TECHNICAL SERVICE BULLETIN

Classification: DA23-008A	Reference: NTB24-002A	Date: March 1, 2024
------------------------------	--------------------------	------------------------

DTCS C1B53-04 AND/OR C1B54-04 STORED IN THE ADAS CONTROL MODULE

APPLIED VEHICLES: 2019-2024 Kicks (P15)
APPLIED DATES: 2019-2023 Kicks – All
2024 Kicks – Built on or before January 19, 2024
APPLIED SYSTEMS: Side Obstacle Warning System

Figure 1

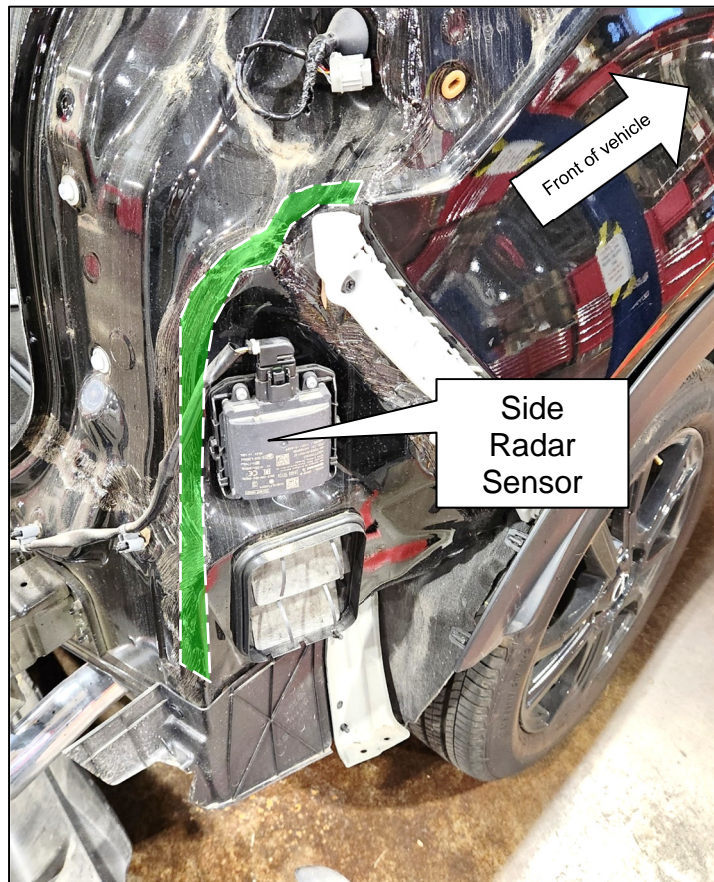
1. Clean the area shown in Figure 1 with isopropyl alcohol.

Figure 3

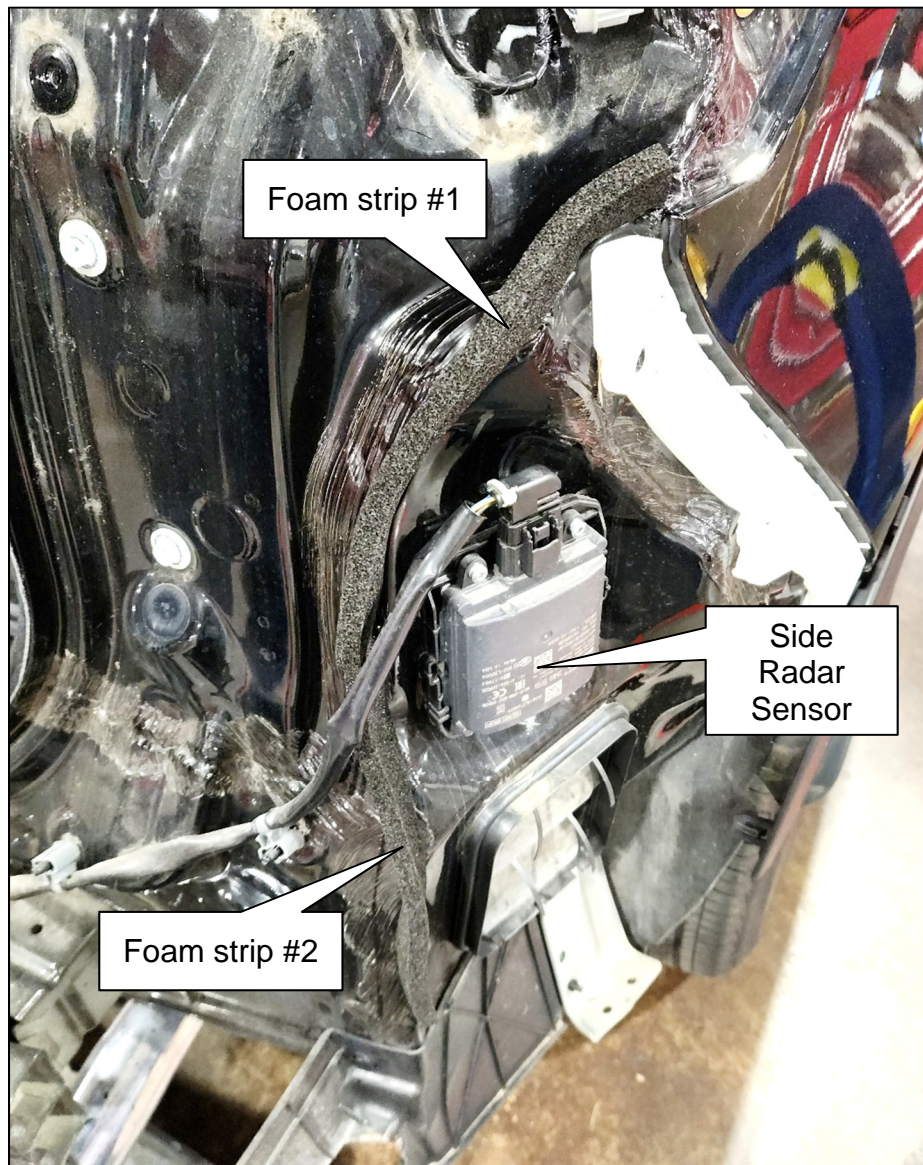
- Using two (2) foam strips, place the foam strips in the locations shown in Figure 3.
